**Project**  
 RICHMOND FOOTBALL CLUB REDEVELOPMENT  
 PUNT ROAD OVAL  
 RICHMOND VIC 3121

## DELEGATE REPORT MINISTERIAL PLANNING REFERRAL

<b>City of Melbourne file reference:</b>	<b>ID-2022-1</b>
<b>PS Amendment No.</b>	C421MELB
<b>Applicant:</b>	Richmond Football Club
<b>Owner:</b>	Crown Land
<b>Architect:</b>	COX Architecture Pty Ltd
<b>Address:</b>	Punt Road Oval, Yarra Park, Punt Road, East Melbourne
<b>Proposal summary:</b>	Planning Scheme Amendment C421melb under Section 20(4) of the P&E Act 1987 to introduce a site-specific Incorporated Document and Specific Controls Overlay over the subject site, allowing the redevelopment of Punt Road Oval.
<b>Cost of works:</b>	\$65 million
<b>Date notice received by City of Melbourne:</b>	15 February 2022
<b>City of Melbourne Status</b>	Consultee (notice received under S.20(5) of the <i>Planning and Environment Act 1987</i> )
<b>Responsible officer:</b>	Colin Charman, Principal Urban Planner Ciara Cancian, Senior Urban Planner

It is recommended that Council advise the Minister for Planning that Amendment C421melb is supported, subject to the conditions of the Incorporated Document being revised in the manner set out in Attachment 1

**Excerpt from Drawing No.A-15-01 'Demolition Plan – L1 Swinburne Centre'**

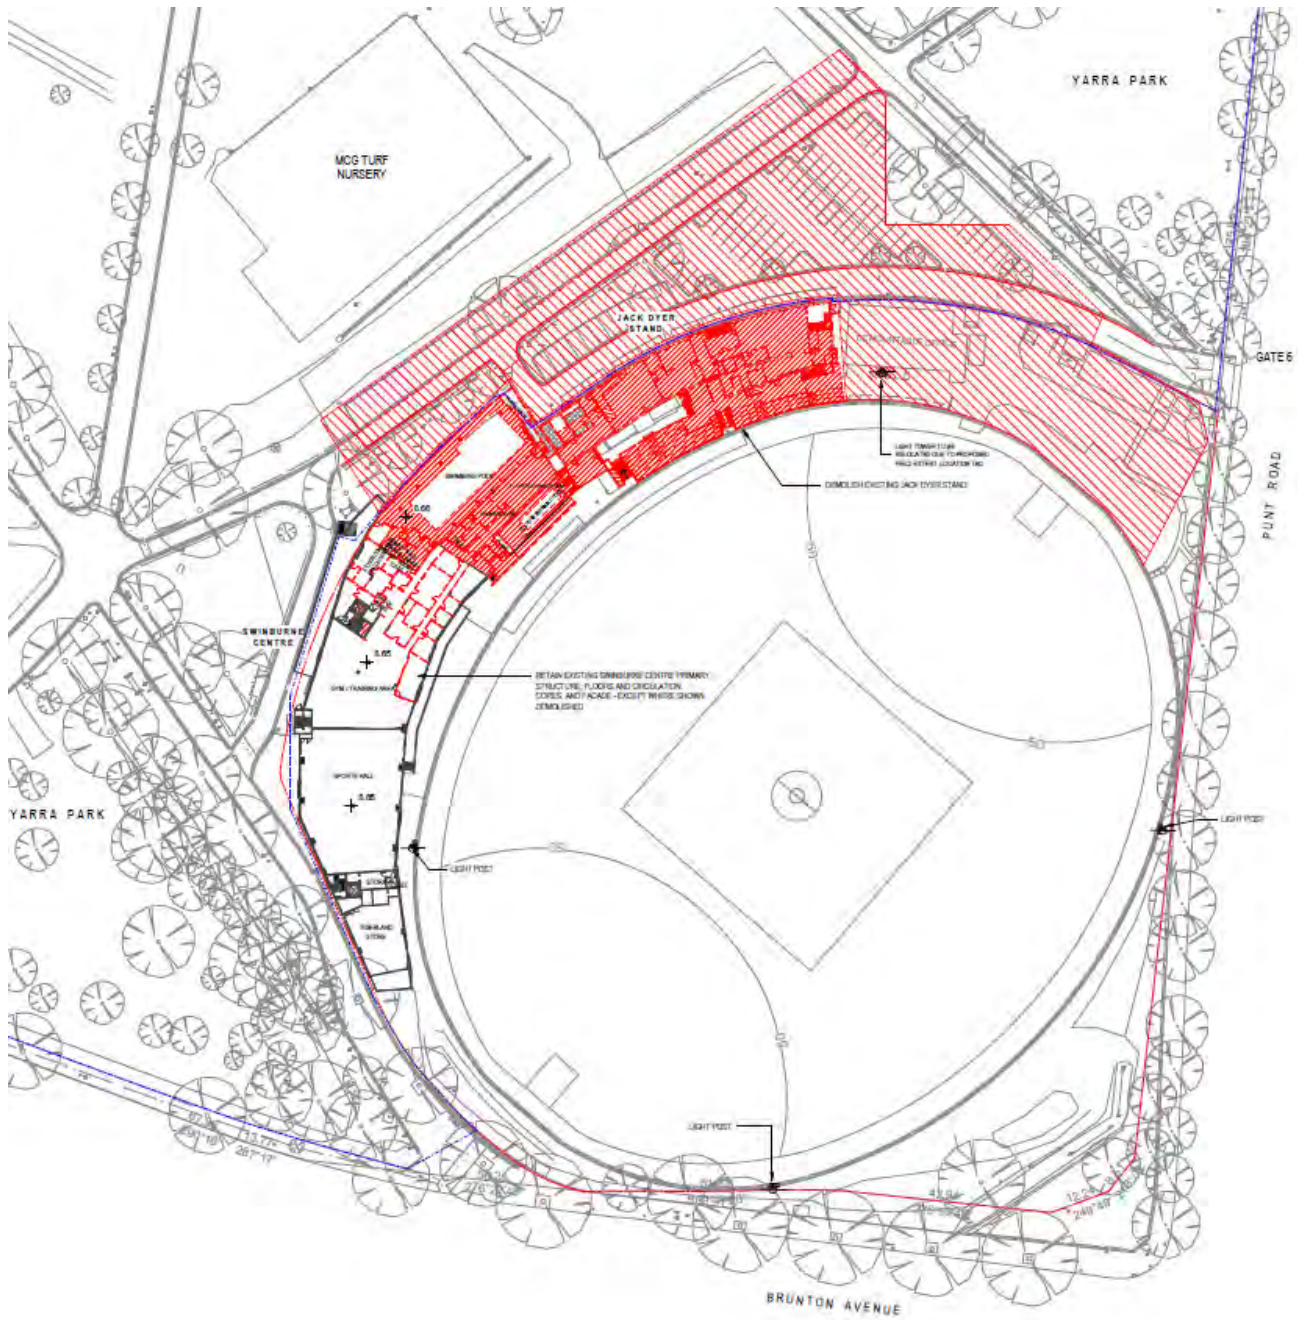
*It is clear that the policy expectation of the Melbourne Planning Scheme with respect to heritage is that the Jack Dyer Stand should be conserved. The demolition of the building would result in loss of heritage significance that goes well beyond the loss of "a buildings that is likely fondly regarded by the RFC members and supporters and other visitors to Punt Road Oval and is familiar to those passing along Punt Road and within Yarra Park". This trivialization of heritage significance provided at Section 7.1 Demolition of the HIS should be accorded no weight as it would equally justify the demolition of a great many other heritage buildings.*

*This deference to the Urbis report does not provide any meaningful justification for how these other planning considerations can, or should, be balanced against the evident adverse impact on heritage significance of the Punt Road Oval with removal of the primary demonstration of the depth of time over which the place has been used.*

*That the limited exploration of development Options provided in the Urbis Planning Report at 3.1.1 Expanded Oval can be taken as satisfactory response to the proposed contravention of the heritage provisions of the Melbourne Planning Scheme lacks any credibility.*

*A demolition permit should not be granted until the proposed replacement building or works have been approved.*

- Require the preparation of a building survey plan of the Jack Dyer Stand (including significant features / elements of the building) to accurately record the important and historic architectural contribution made by this structure to grand stands in Melbourne (to be prepared by a licensed surveyor) and photographic record of the Jack Dyer Stand to be undertaken for archival purposes, and require the display / integration of key identified features / elements into the new building.

- Require careful demolition of the Jack Dyer Stand, to facilitate salvage and reuse of original bricks and other important elements to be incorporated into the podium of the William Cooper Centre, and interpretive re-use within the landscaped terrace.

Excerpt from Drawing No.A-40-01 'General Sections – Sheet 01'

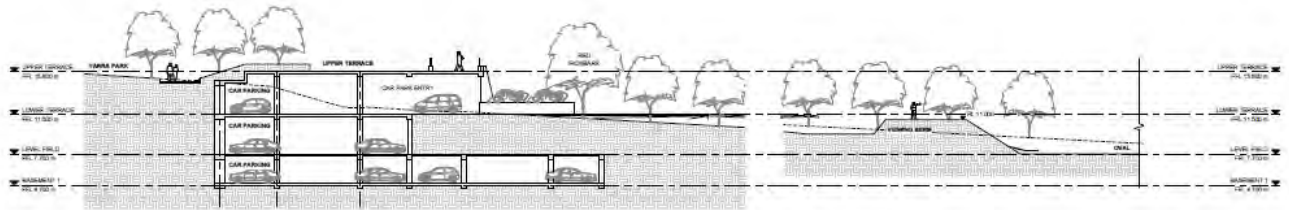
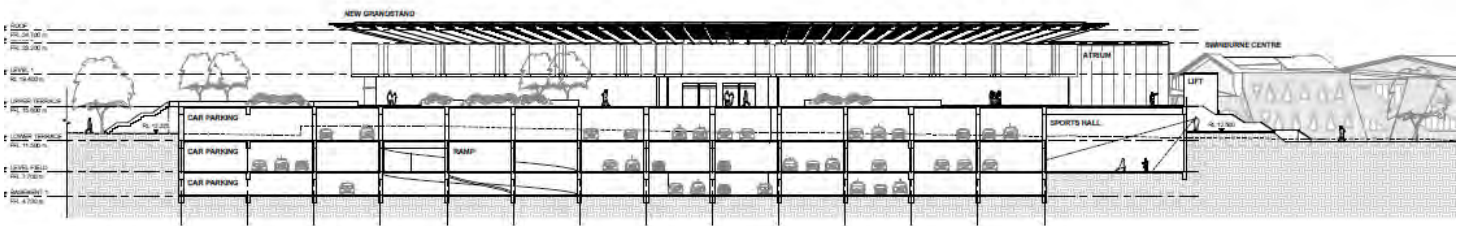
3D renders provided with the Architectural Design Response package prepared by Cox Architecture (see Section 4.4 of this report) demonstrate that the scale of the proposed William Cooper Centre, while larger than the existing historic Jack Dyer Stand and administration building extension, has been sensitively designed to ensure that it does not visually dominate Yarra Park.

Contributing to the subdued impression of the scale of the new structure from Yarra Park is a steep embankment to the north of the site, which accounts for a level change in the order of 4 metres.

**Site Photograph showing obstruction of views into Punt Road Oval from Yarra Park (captured: 1-Apr-22)**

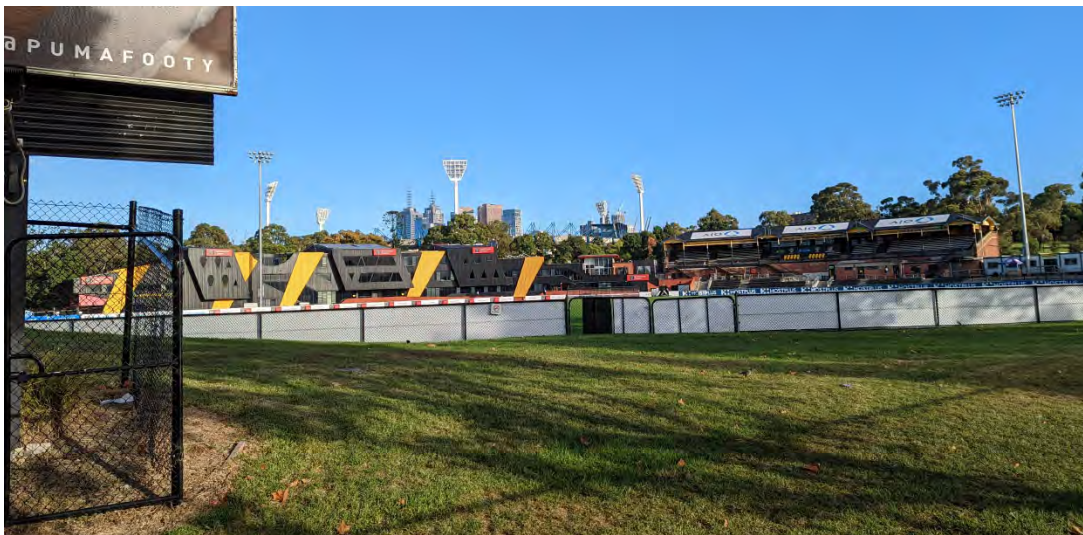
Formalising a 'Signage Strategy' in the Incorporated Document with appropriate restrictions on barrier signage would contribute to the public benefit provided by Amendment C421melb, and would support conservation of the heritage significance of Punt Road Oval by providing an improved, sympathetic, setting for the oval in Yarra Park, addressing Council's Heritage Policy.
